Product Change Notice

ECOM-165390

SOM-5871 PCIe x1 lanes reduce due to PLX PEX8605-AB50TQI PCIe Bridge EOL and no replacement.
All PCIe x1 lanes will be changed to connect from chipset directly. For detail, please refer to the appendix.
Before change (with PEX8605-AB50TQI): I210 LAN + 6 PCIe lanes for max. 6 devices
After change (without PEX8605-AB50TQI): I210 LAN + 5 PCIe lanes for max. 4 devices

1. Comparison of SOM-5871 PCIe Configuration

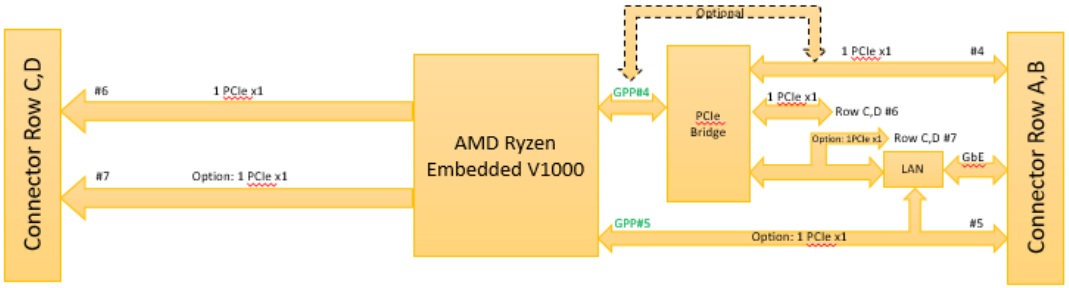
STD-P/N Users:
All STD-P/N models will remove **1410024446-01** due to no replacement P/N from vendor side. SOM-5871 SPEC will be changed accordingly.
T-P/N & Fixed BOM P/N users:
For T-P/N & fixed BOM models, please inform customers to change the PCIe devices usage of their system accordingly.

SOM-5871 with 1410024446-01: Support **6** PCIe Lanes

SOM-5871 remove 1410024446-01: Support **5** PCIe Lanes
